TANC COMMENTS ON THE CAISO'S DRAFT 2013-2014 TRANSMISSION PLAN

The Transmission Agency of Northern California (TANC) appreciates this opportunity to provide comments on the California Independent System Operator's (CAISO) Draft 2013-2014 Transmission Plan. Review of the draft Transmission Plan indicates that it does not address written comments which TANC submitted on October 10, 2013 and December 11, 2013, or the comments made by TANC at the Transmission Planning Process (TPP) Stakeholder meetings on September 25 and 26, 2013 and November 21, 2013. TANC's earlier comments focused on the reliability assessment results for the Pacific Gas and Electric Company's (PG&E) bulk transmission system and on how issues (such as the unavailability of existing Remedial Action Scheme (RAS) and system modeling inaccuracies) associated with the PG&E bulk system could impact the California-Oregon Intertie (COI) and the California-Oregon Transmission Project (COTP), which is a major component of the COI and for which TANC is the Project Manager and largest Participant.

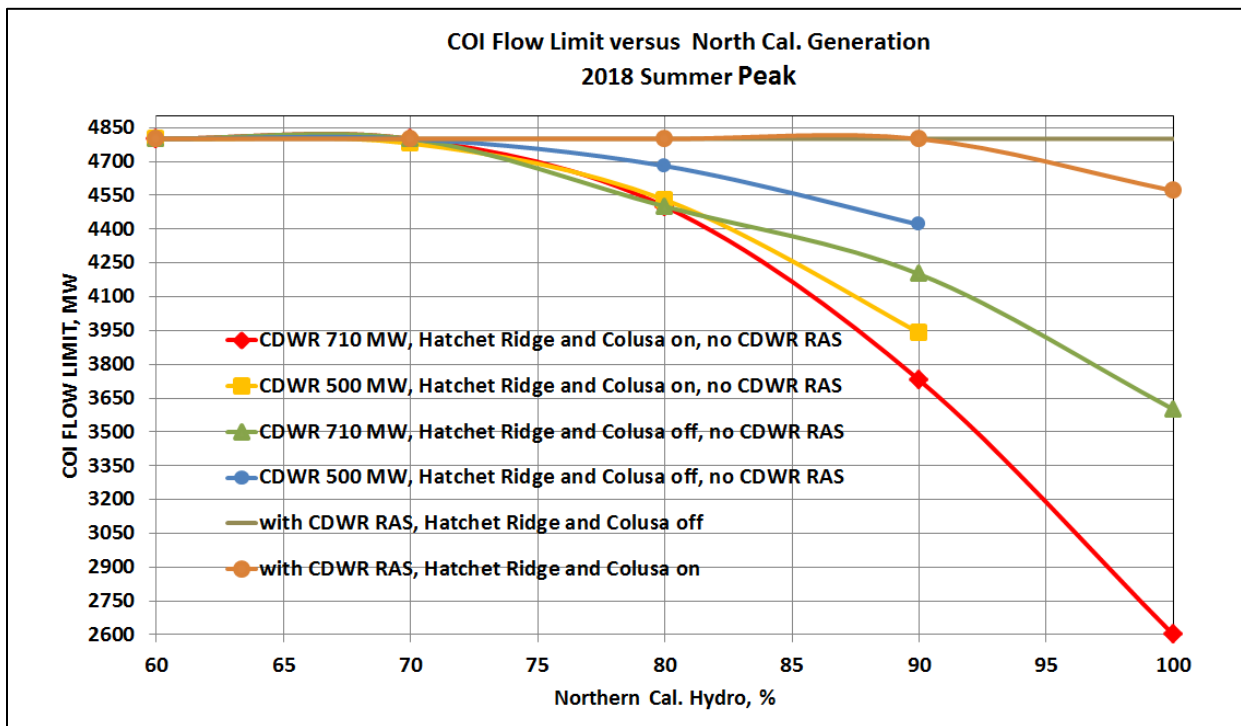
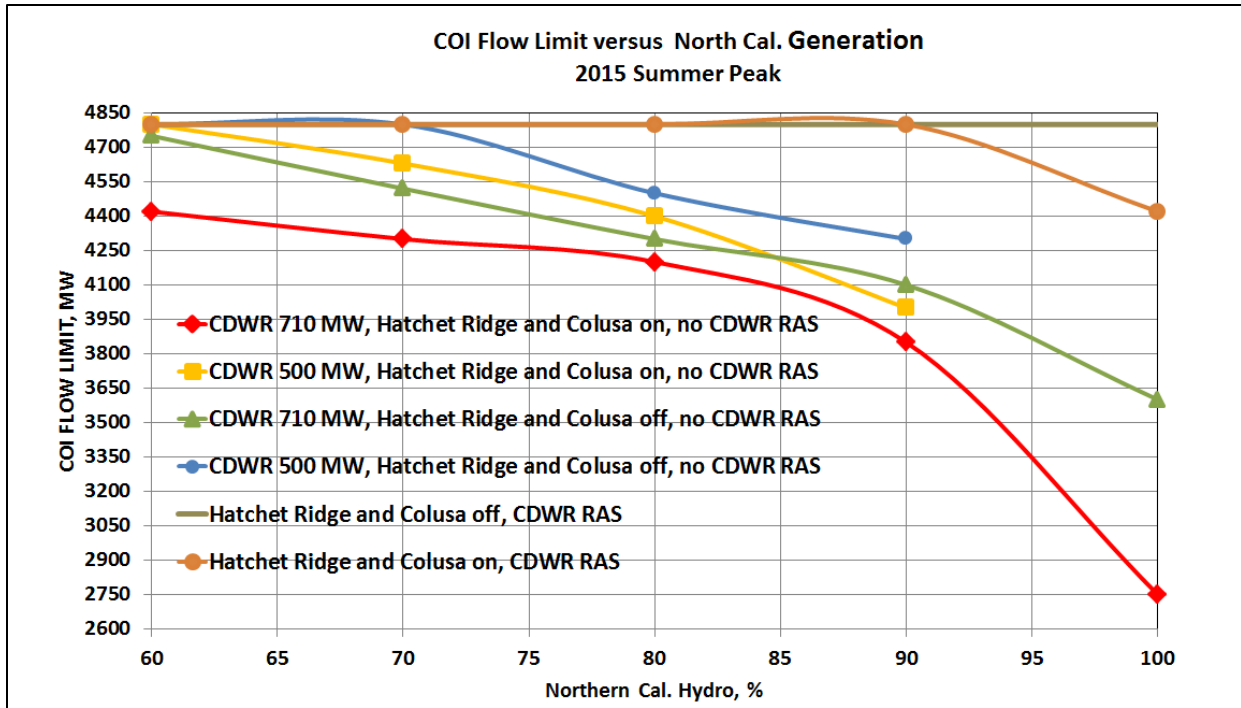
Appendix B to the draft Transmission Plan contains nomograms for 2015 and 2018 (Figures B1.2-4 and B1.2-5) that depict the COI flow limits for different levels of northern California hydro generation and for various scenarios with and without the DWR RAS (refer to the nomograms on Page 4). Appendix B also contains two tables (Tables B1.2-1 and B1.2-2) that summarize the information on the nomograms as well as provide information as to the limiting facility for the pertinent operating point. As noted above, both the 2015 and 2018 TPP bases case used in developing these nomograms contained modeling inaccuracies.

The decreases in the COI flow limit at the 80 percent hydro level for the 2015 and 2018 cases, as depicted in the above mentioned nomograms, are summarized in Table 1.

Preliminary studies by TANC that utilized the posted TPP cases (in which the CDWR generation was at 710 MW in 2015 and at 806 MW in 2018, Colusa generation was at 690 MW in both cases, and Hatchet Ridge generation was at 103 MW in both cases), indicate that the above reductions in the COI flow limit would likely be much larger if the modeling deficiencies in the 2015 and 2018 TPP cases were corrected. Specifically, these studies indicate that:

- The reductions to the COI flow limit in 2015 would be 1,500-1,600 MW higher than the values noted above; and
- The reductions to the COI flow limit in 2018 would be 1,200-1,300 MW higher than the values noted above.
